Technical Service Bulletin

TSB0219
2018 CX65 Swingarms

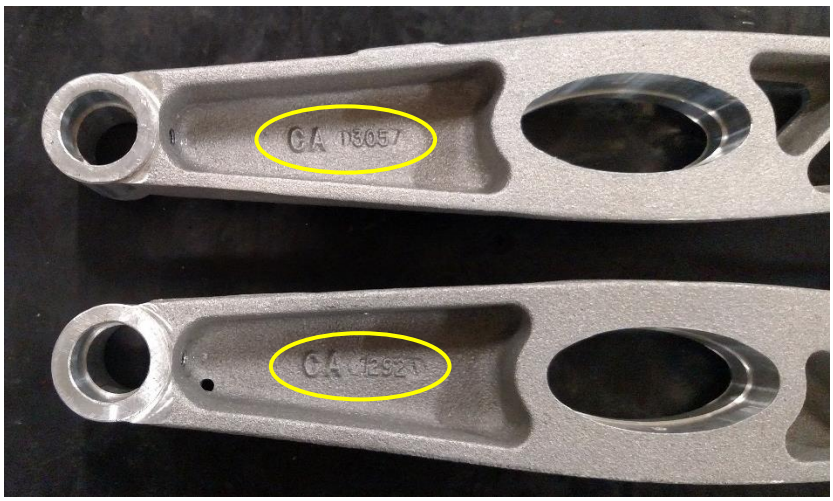
Swingarms produced with casting code CA292 or CA305 are prone to failure. Swingarms with any other casting code including CA087 or any code of 4 digits followed by a letter (like 4132A) are okay to continue using.

To look for casting codes, one should look inside the swingarm side arms behind the swingarm pivot and in front of the shock mount. The codes on the swingarms shown below are CA305 and CA292.

It is recommended that these motorcycles not be ridden until which time Cobra can provide customers updated replacements swingarms. We are scheduling these to start shipping in late September 2018. Please call Cobra Customer Service and have your VIN along with swingarm code.

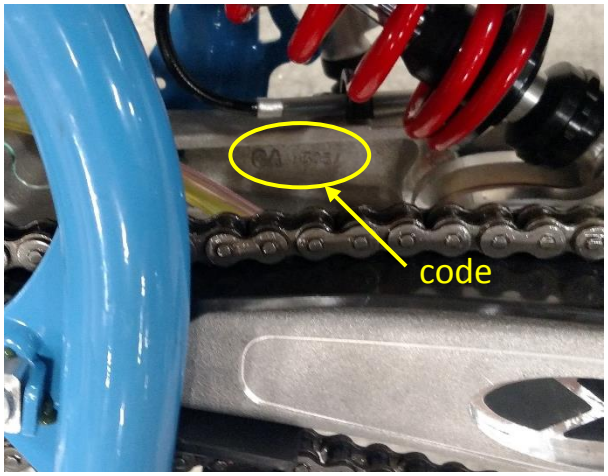
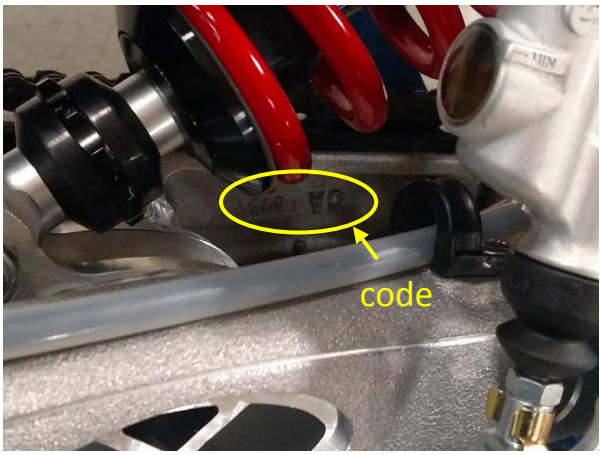
The pictures below show the where the casting codes can be seen on the motorcycle.

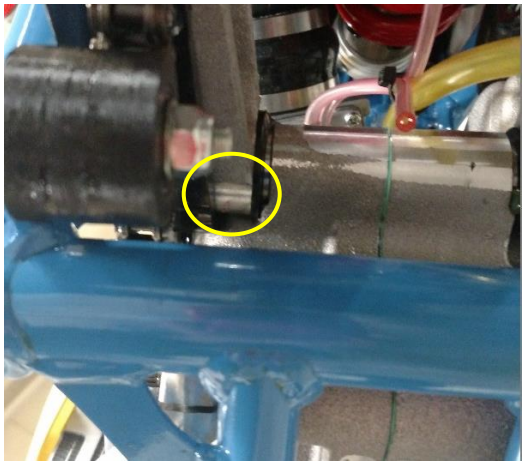
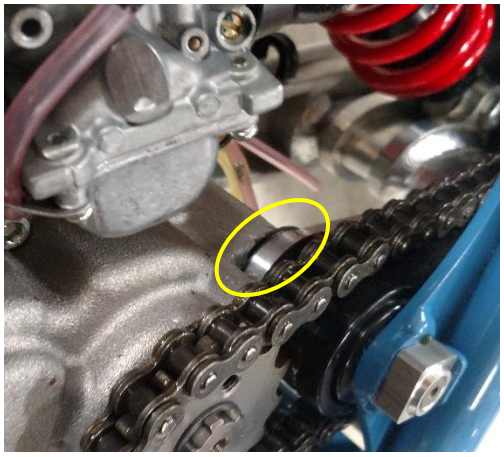
To look for cracks, one must clean thoroughly and then look above and below the swingarm pivot.
